< PL2215P/2415 Change Section >

1. RX Part : IF IC change

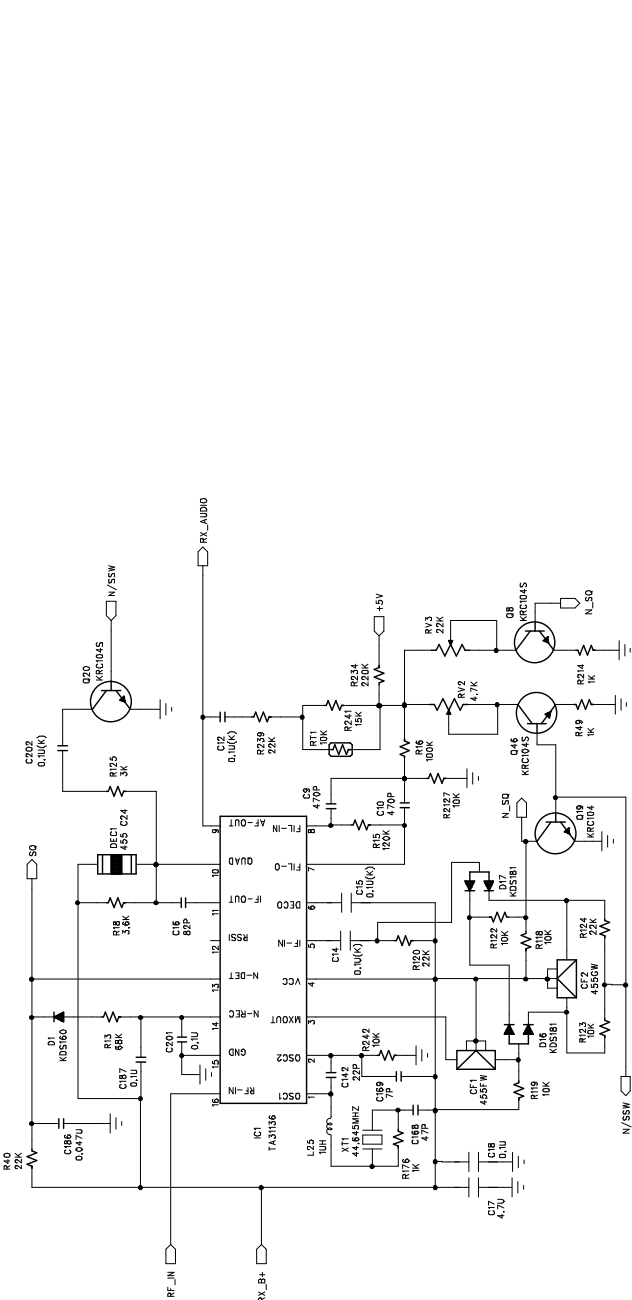
==> Before (DBL5018 / SL5018)

==> After (TA31136)

2. PLL and VCO Part

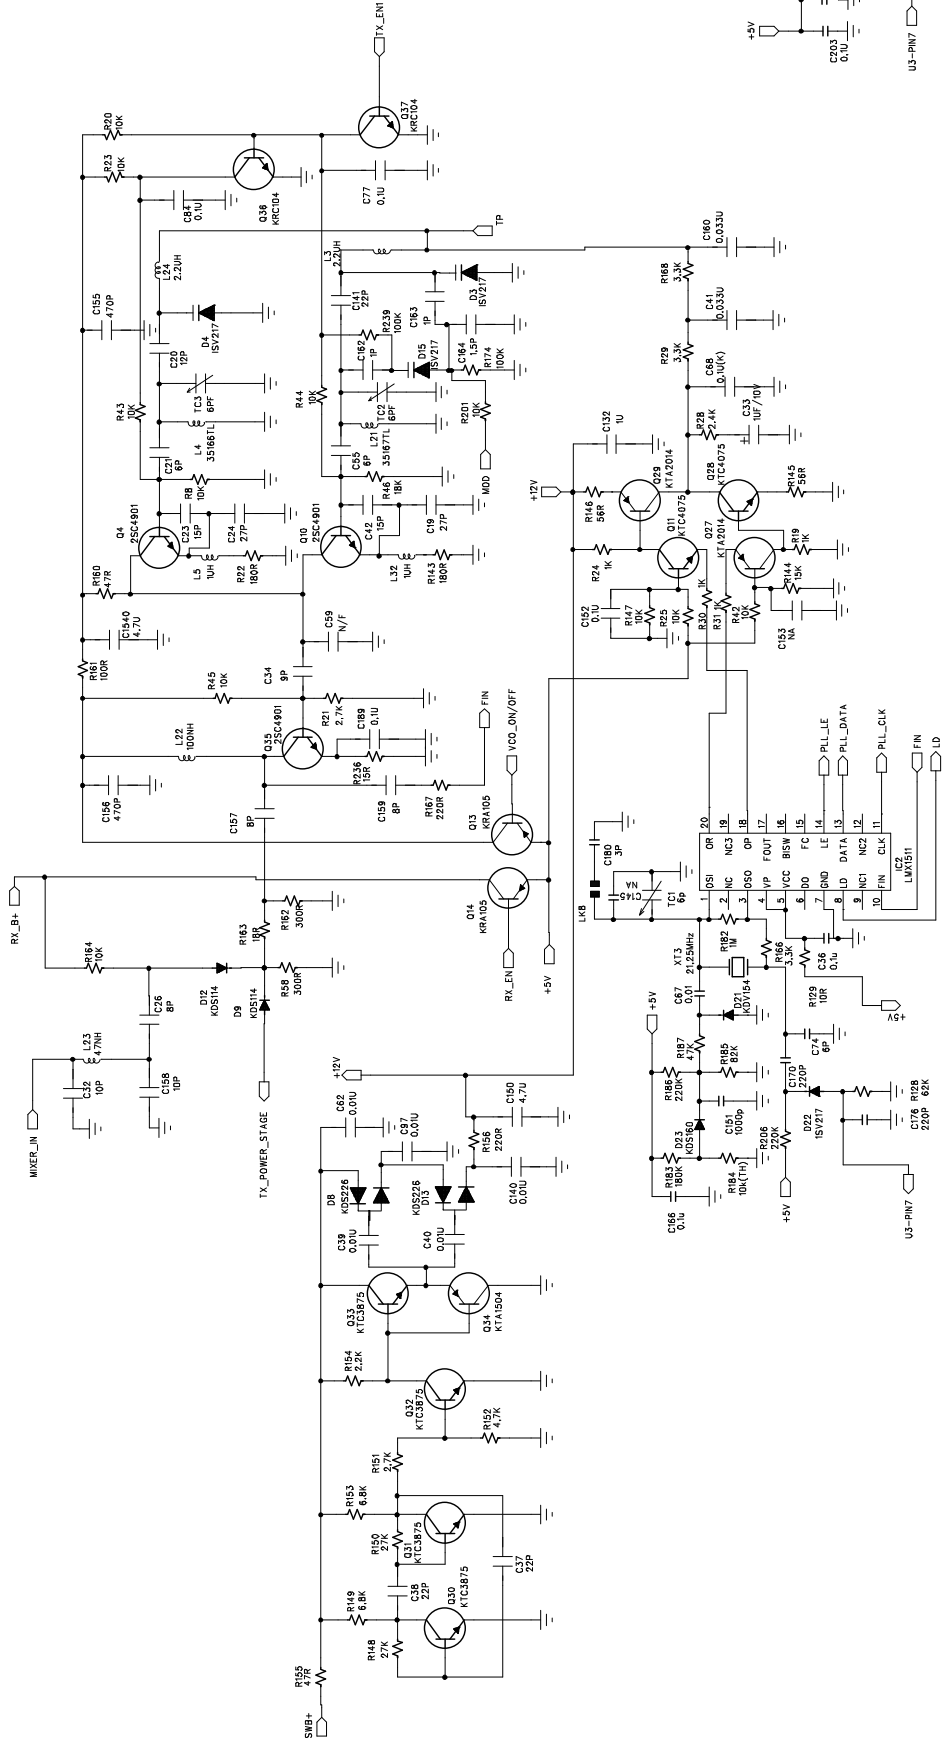
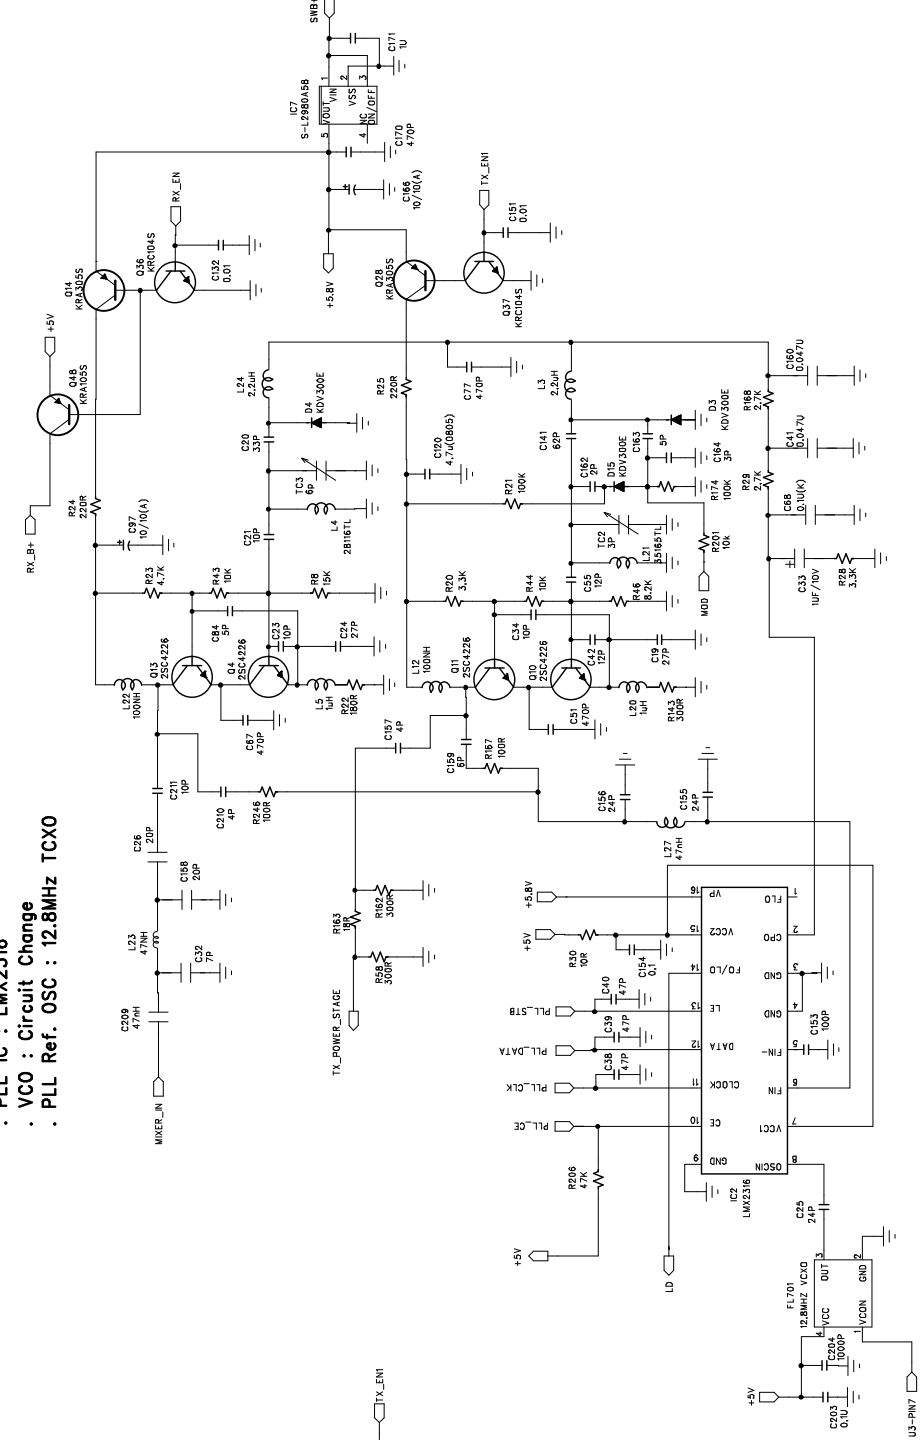
- PLL IC : LMX1511
- PLL Ref. OSC : 21.25MHz X-TAL

- DC to DC Converter :Delete
- Charge pump : delete
- PLL IC : LMX2316
- VCO : Circuit Change
- PLL Ref. OSC : 12.8MHz TCXO

3. TX Part

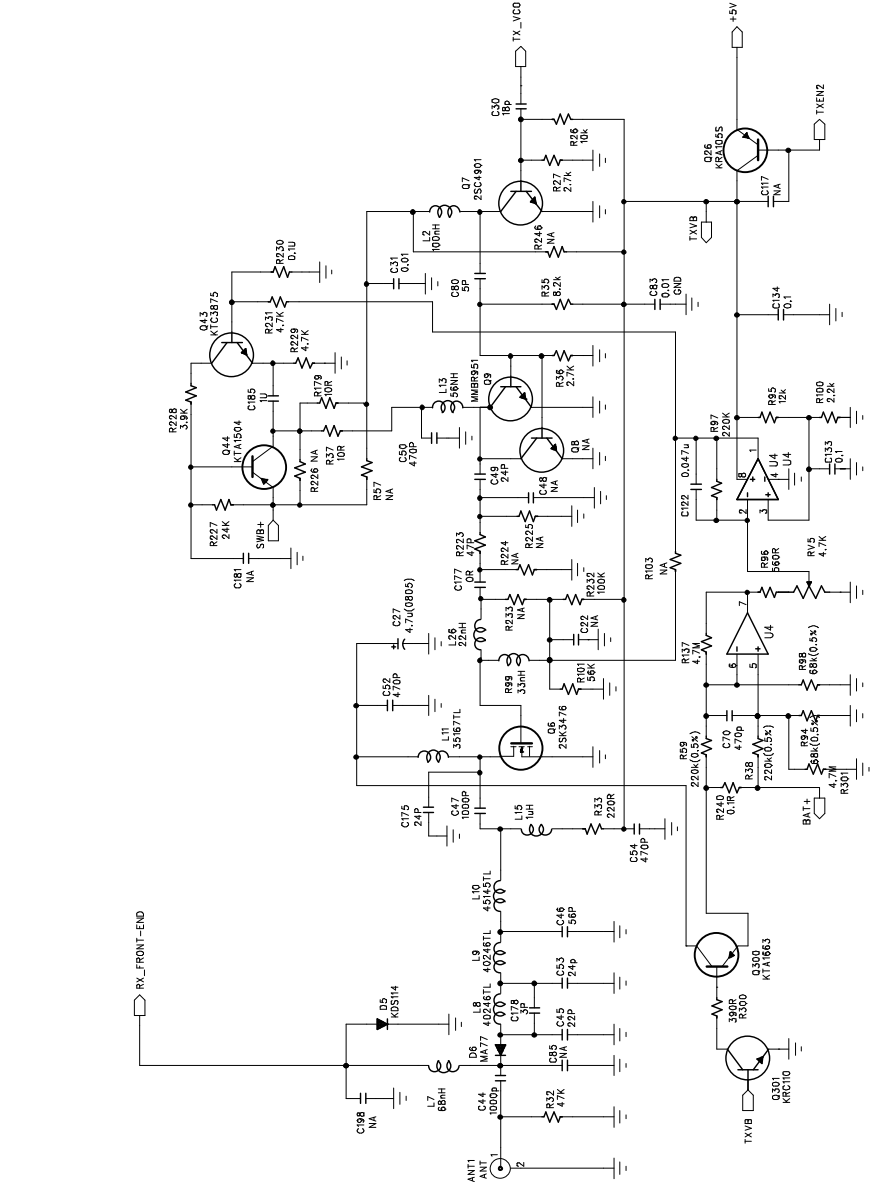
- change TX low pass filter and matching circuit of final FET(Q6)
